Cleanup Action Plan

Sterling Realty Organization
Bellevue Corner Property
10605 and 10619 NE 8th Street
Bellevue, Washington

~~December 22~~ April 10, 2014

Geologic Cross Section A-A'	
SRO, 10605 and 10619 NE 8th Street Bellevue, Washington	
GEOENGINEERS	Figure 4

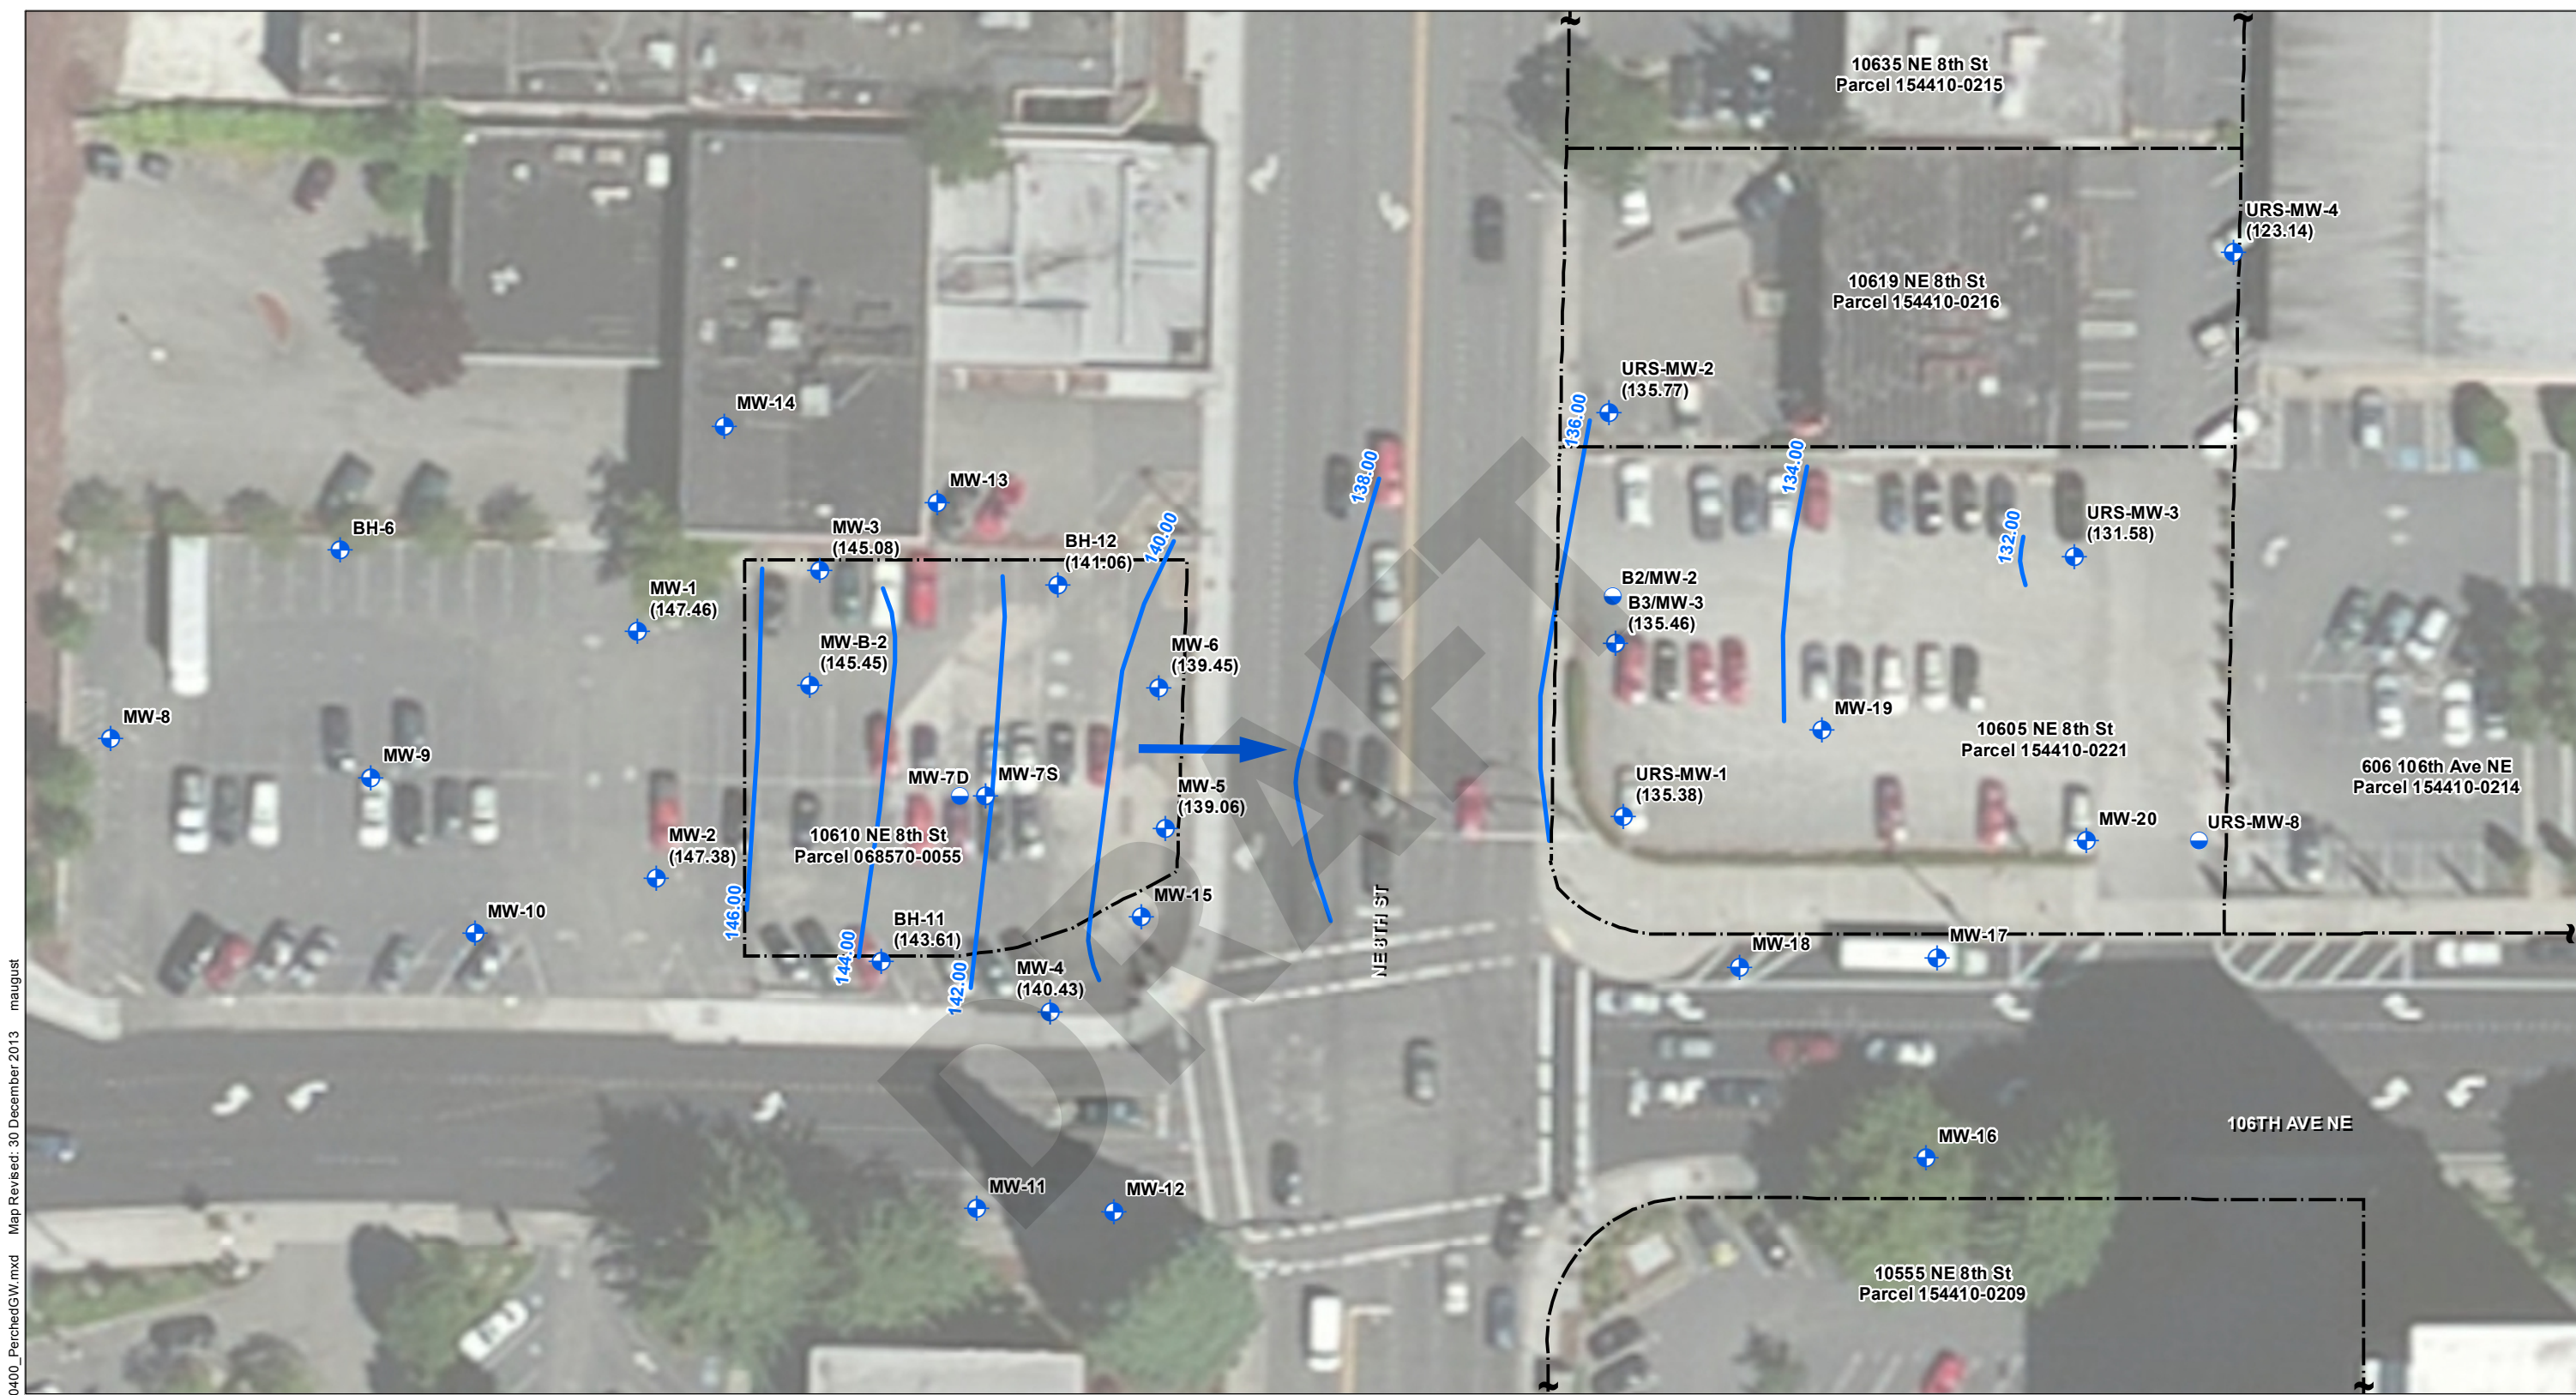
Commented [j3]: Added planned excavation extent and geologic contacts to Figure 4

PCE Soil Contamination Cross Section B-B'	
SRO, 10605 and 10619 NE 8th Street Bellevue, Washington	
GEOENGINEERS	Figure 10

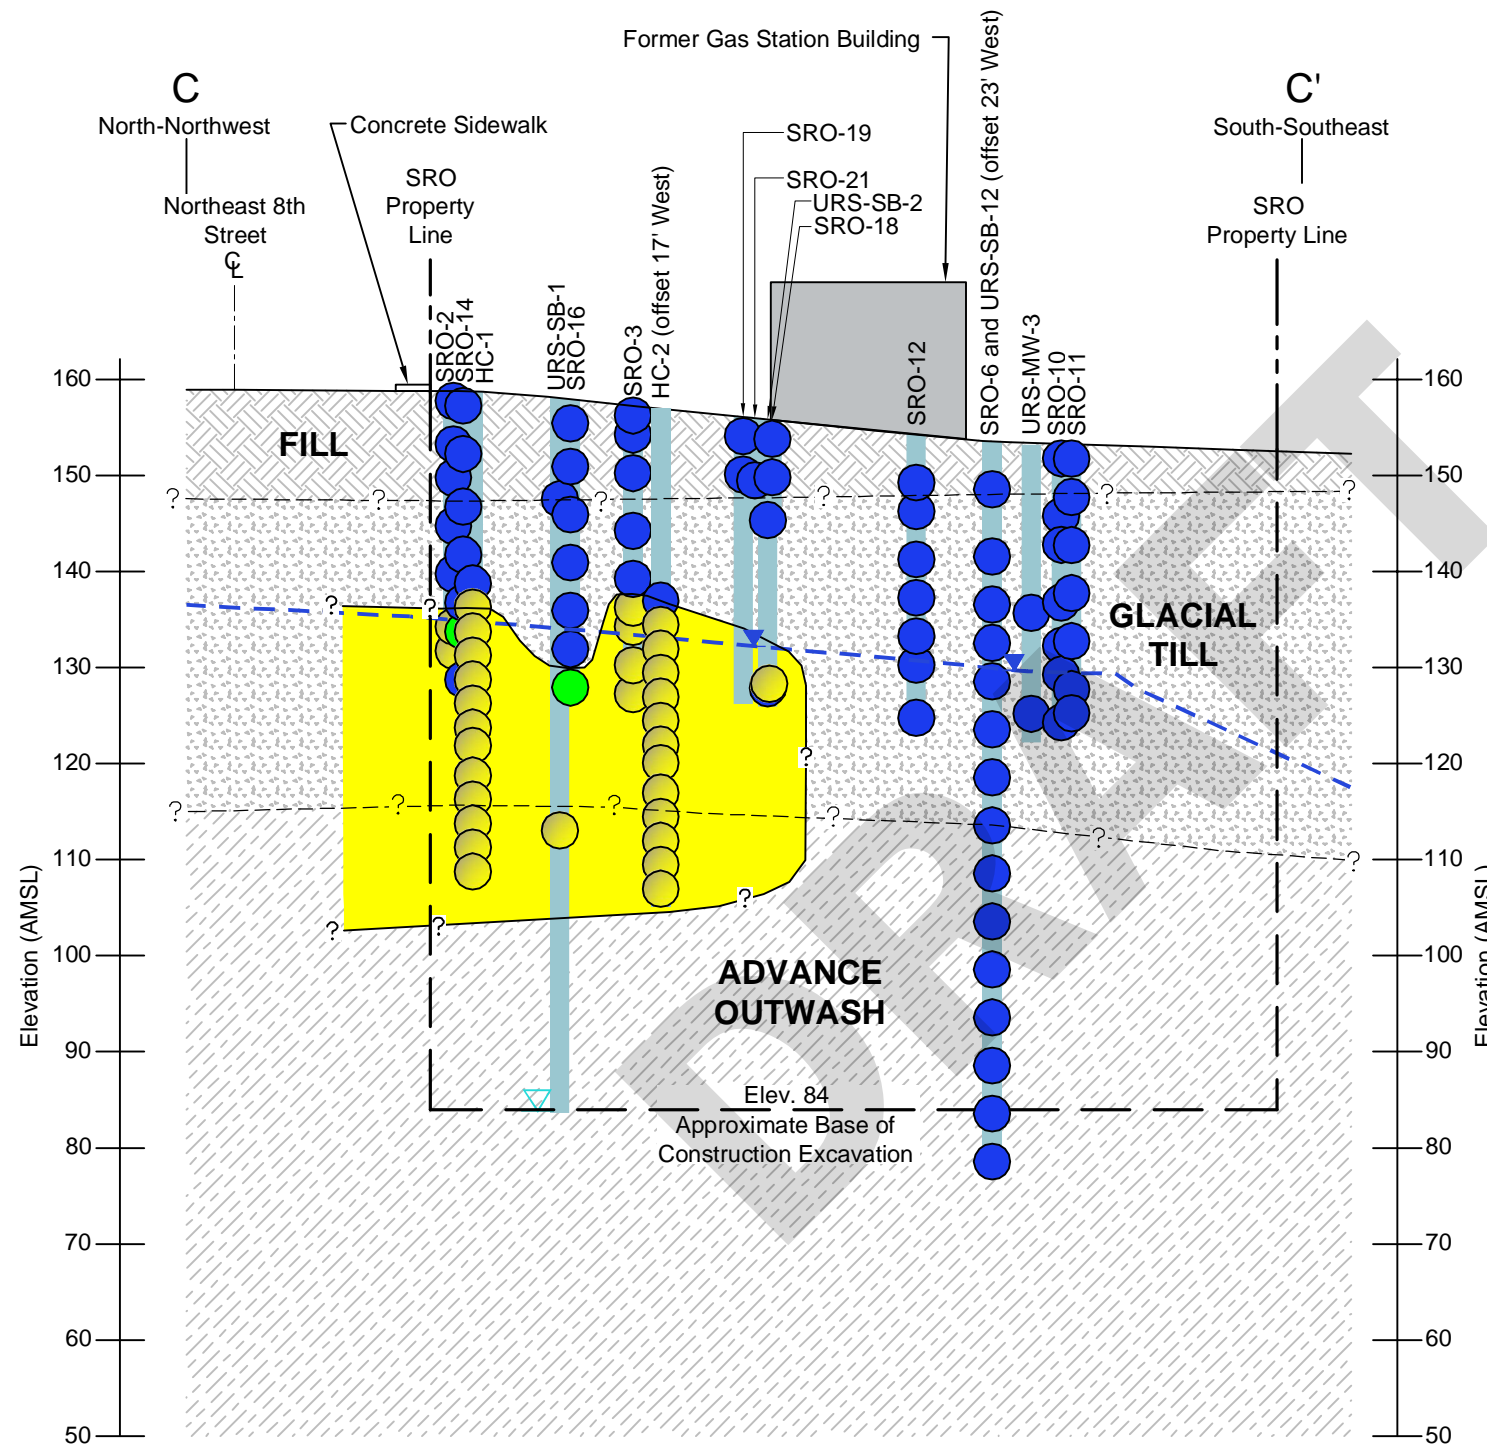
Commented [j5]: Added planned excavation extent and geologic contacts to Figures 10 & 11
